<u>Daun, Mary</u>
<u>Joe Gay</u>
Kevin Roy; Colby, Jaime
June 12, 2024 NCES site visit
Thursday, June 13, 2024 2:24:00 PM
NCES site visit report 6-12-2024.pdf

Facility/ Site Information				
North Country Environmental Services Inc / DES-SW-SP-03-002				
North Country Environmental Services Inc.				
581 Trudeau Road, Bethlehem, NH				
1855 VT Route 100, Hyde Park, VT 05665				
Accepted	Other Permit No. / Date Issued			
, C&D, Contaminated Soil,	Groundwater Permit: GWP-198704033			
	North Country Environment 581 Trudeau Road, Bethleh 1855 VT Route 100, Hyde P Accepted

Visit Information				
Date of Visit	6/12/2024	NHDES Staff Conducting Site Visit	Mary Daun, Jaime Colby	
Time Arrival / Departure	10:18AM / 12:45PM	Weather	Cloudy, 71 - 76°F	
Purpose of Site Visit	Construction Meeting for CAP 4 and Site Visit			
Photos Taken: X Yes No (see end of report)

PXL\_20240612\_151932547: Stormwater swale near Cap 4 area

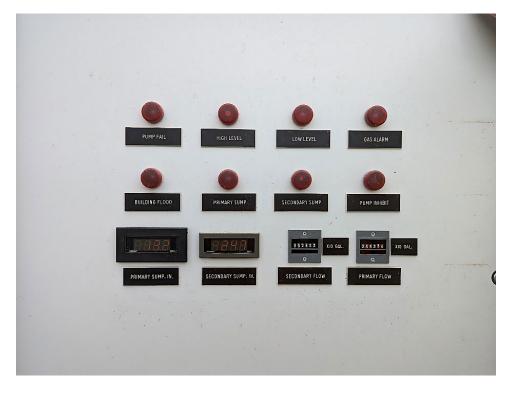
NHDES staff, Joe Gay, Kevin Roy, Hunter Whitcomb, and Brett Deyling proceeded on a site walk clockwise around the landfill, primarily to view the work on Cap 4. A stormwater down chute located in Stage V, near Pump Station #1, was reworked within the past week, and other areas on the Stage V slope were repaired or needed repair. In areas of erosion, waste was not observed. See photographs. Intermediate cover was observed over the Cap 4 area. The swale at the toe of the Cap 4 area slope was also cleared of sediment within the past week due to erosion from recent rainstorms. The slope of Cap 4 is about 2.7H:1V. A gas header pipe with a pitch issue was excavated and reset on the northeast side of the landfill, in the Cap 4 area. NHDES staff observed waste on top of the intermediate cover in this area. NCES stated that they would cover it in the afternoon of the same day.
